## Changes to proposed District Map Amendment G-956

A revised version of DMA G-956, dated April 18, 2014, has been posted on the Planning Department website for review. It contains all of the proposed and approved changes that have occurred since March 7, 2014. The following document illustrates all of the changes to DMA G-956.

Changes made to DMA G-956 are organized into two sections, each section describing a different type of revision.

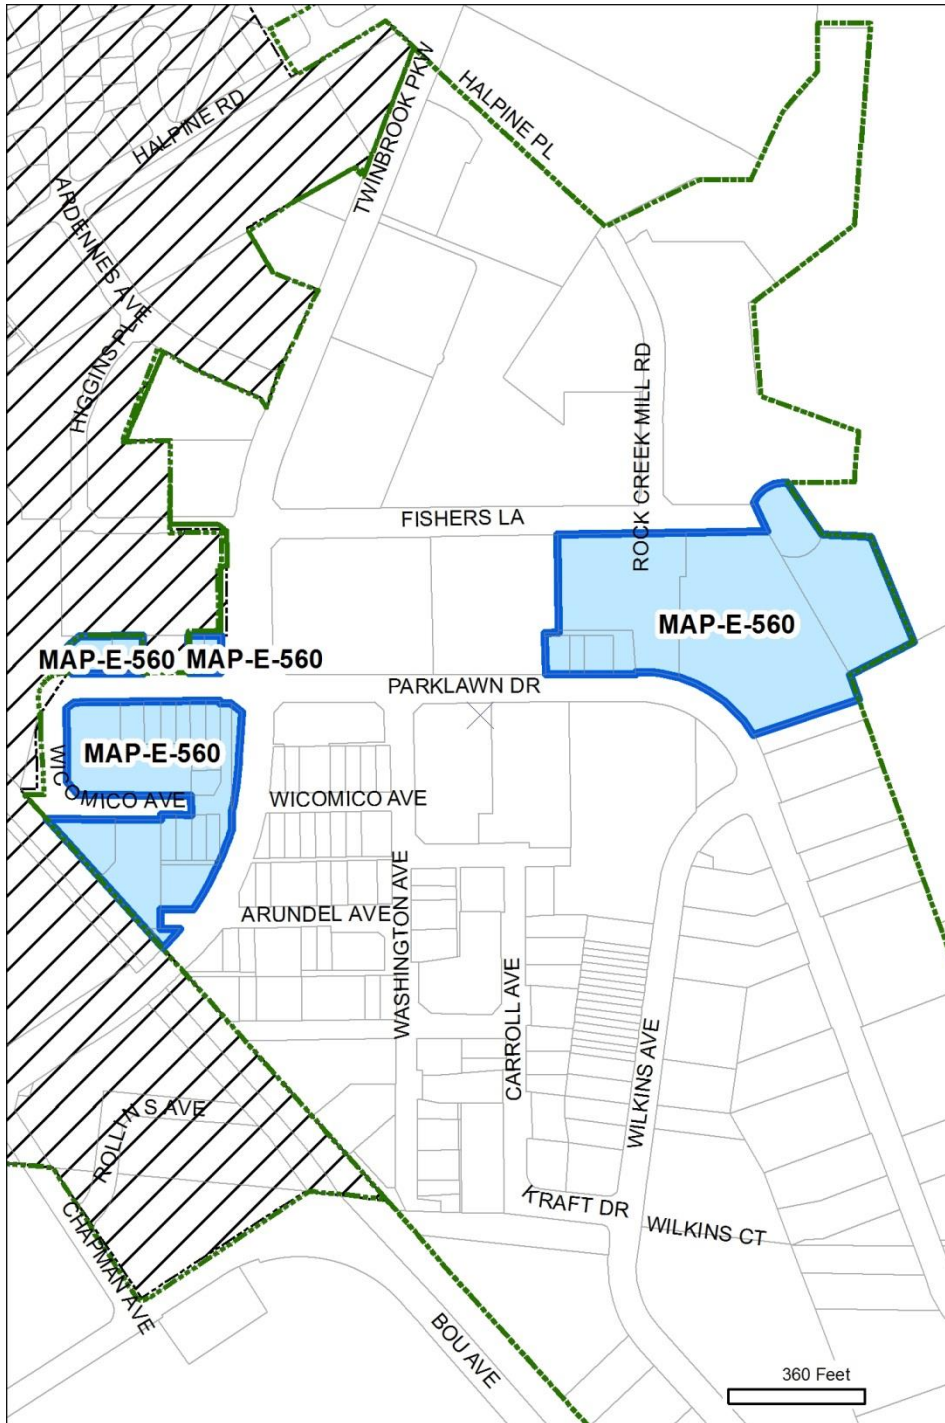
Unique ID: MAP-E-559		staff error
Master Plan ID: TWBRK-05		
Master Plan:	Twinbrook	
Location:		
Existing Zone:	TMX-2	
Proposed Conv: (3/7)	<del>CR-2.0 C-1.5 R-1.5 H-150 T</del>	
Prop. Revised Conv:	CR-2.0 C-1.5 R-2.0 H-145 T	
Category:	Error	
Modifications	Zone Group:	No change
	Overall FAR:	No change
	Comm'l FAR:	No change
	Resid'l FAR:	Increased to 2.0
	Height:	Reduced to 145
<b>Reason for change:</b>		
<p><i>The sector plan calls for limiting height throughout the sector plan area to 143', so the height should be reduced.</i></p> <p><i>The sector plan also calls for allowing the full density to be used for residential, and staff inadvertently limited residential to 1.5 FAR. Therefore, the residential FAR limit should be increased to 2.0.</i></p>

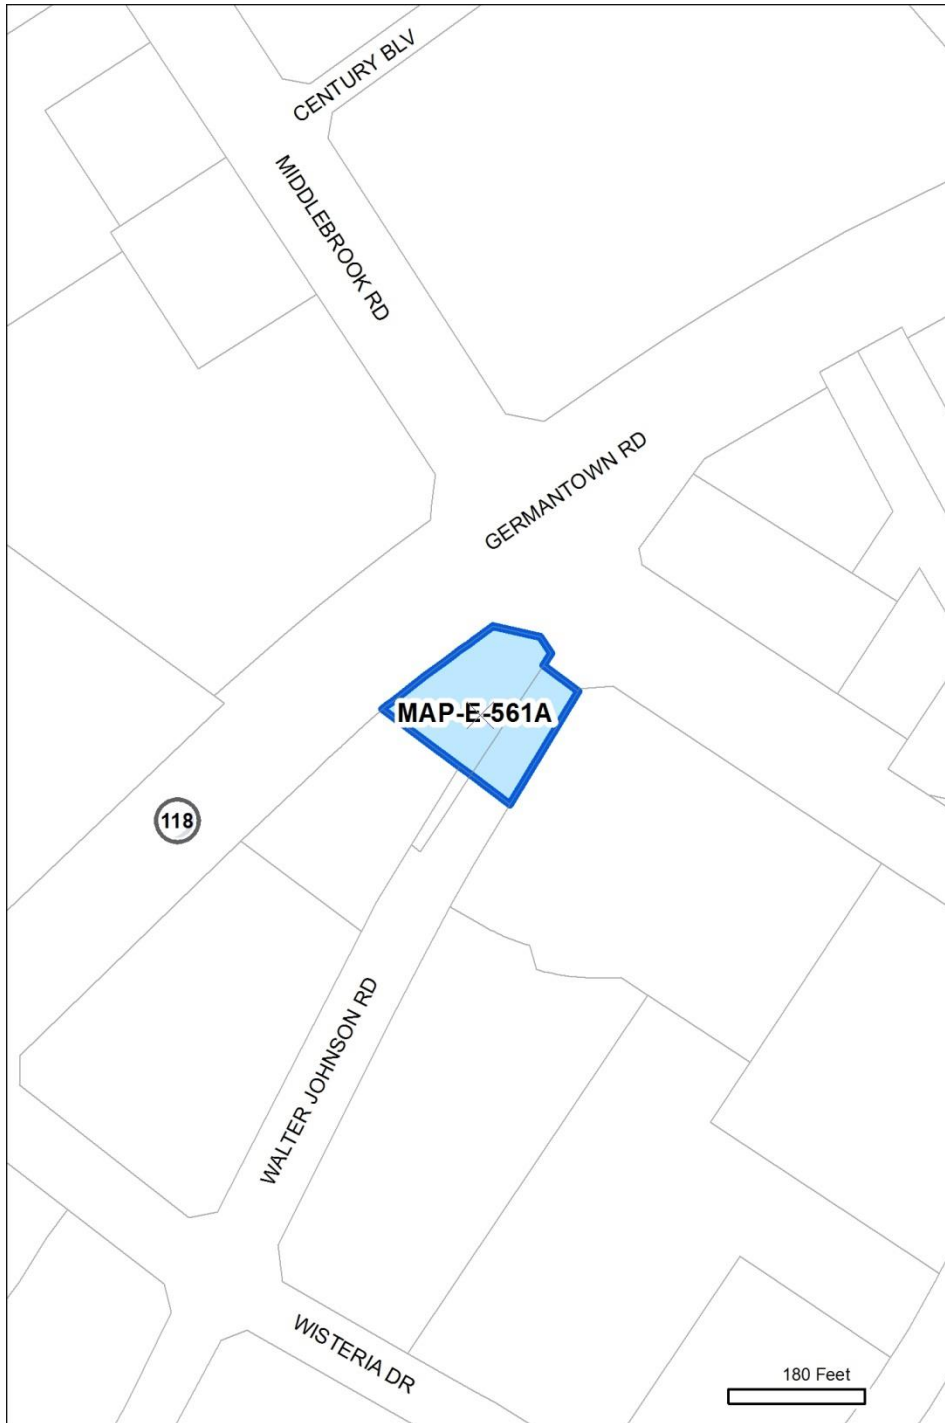
Unique ID: MAP-E-560		staff error
Master Plan ID:		
Master Plan:	Twinbrook	
Location:		
Existing Zone:	TMX-2	
Proposed Conv: (3/7)	<del>CR-2.0 C-1.5 R-1.5 H-150 T</del>	
Prop. Revised Conv:	CR-2.0 C-1.5 R-1.5 H-145 T	
Category:	Error	
Modifications	Zone Group:	No change
	Overall FAR:	No change
	Comm'l FAR:	No change
	Resid'l FAR:	No change
	Height:	Reduced to 145
Reason for change:		
<i>The sector plan calls for limiting height throughout the sector plan area to 143', so the height should be reduced.</i>

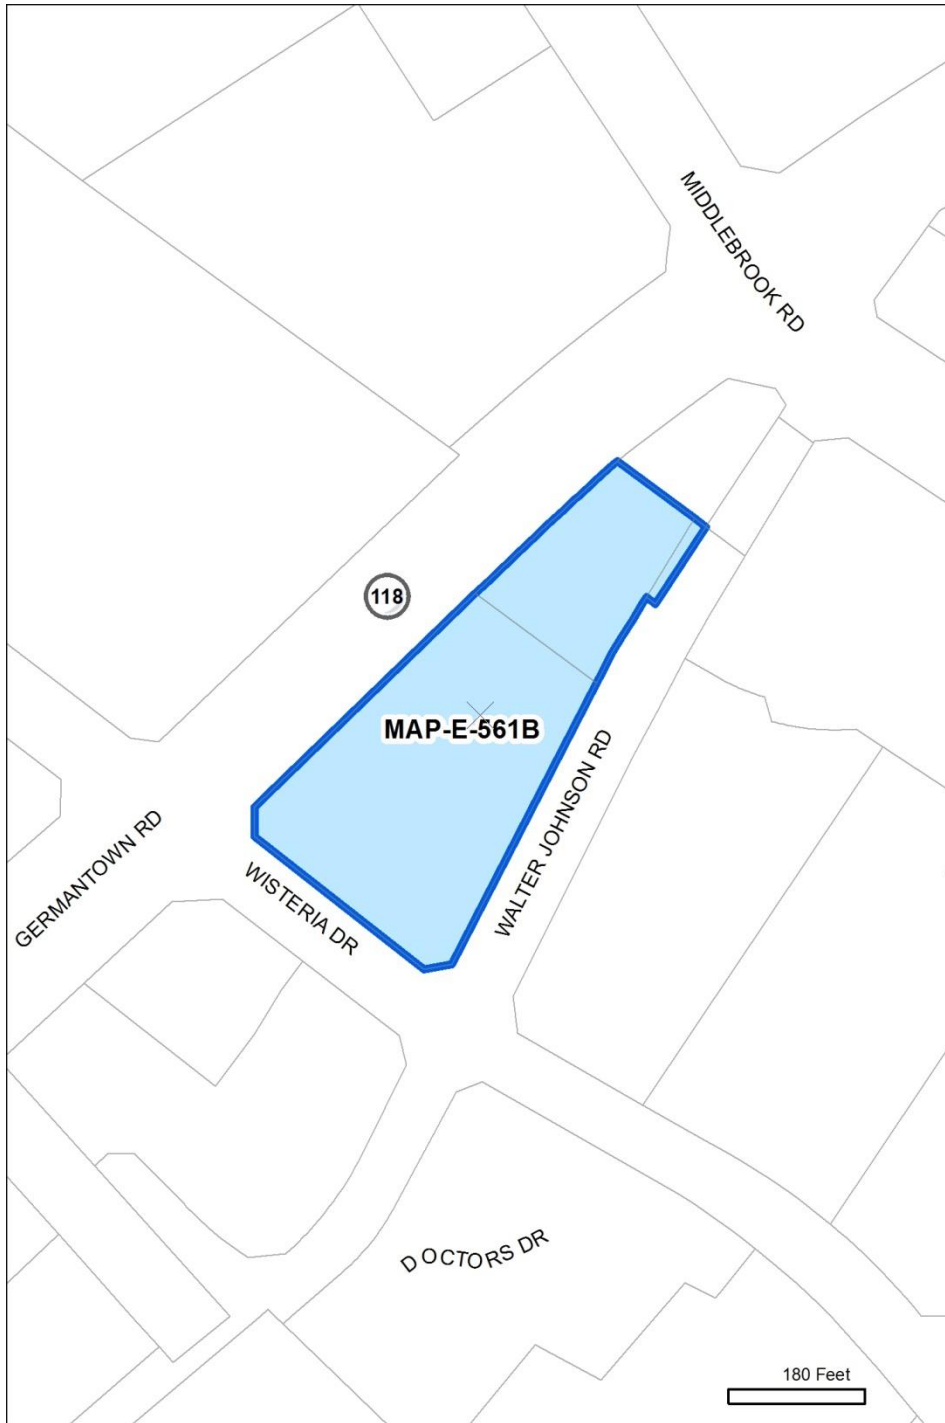
<b>Unique ID:</b> MAP-E-561A		staff error
<b>Master Plan ID:</b> GRMTC-15B		
<b>Master Plan:</b>	Germantown Town Center	
<b>Location:</b>		
<b>Existing Zone:</b>	TMX-2	
<b>Proposed Conv:</b> (3/7)	CR-1.0 C-0.75 R-0.5 H-100 T	
<b>Prop. Revised Conv:</b>	CR-1.0 C-0.75 R-0.75 H-100 T	
<b>Category:</b>	Error	
<b>Modifications</b>	<b>Zone Group:</b>	No change
	<b>Overall FAR:</b>	No change
	<b>Comm'l FAR:</b>	No change
	<b>Resid'l FAR:</b>	Increased to 0.75
	<b>Height:</b>	No change
<b>Reason for change:</b>		
<p><i>The sector plan does not make any specific recommendation about the mix of uses on this site, only on overall FAR (which it limits to 1.0 FAR).</i></p> <p><i>For that reason, residential FAR should be limited to 0.75. Staff inadvertently applied a lower residential FAR based on a recommendation for a neighboring property.</i></p>
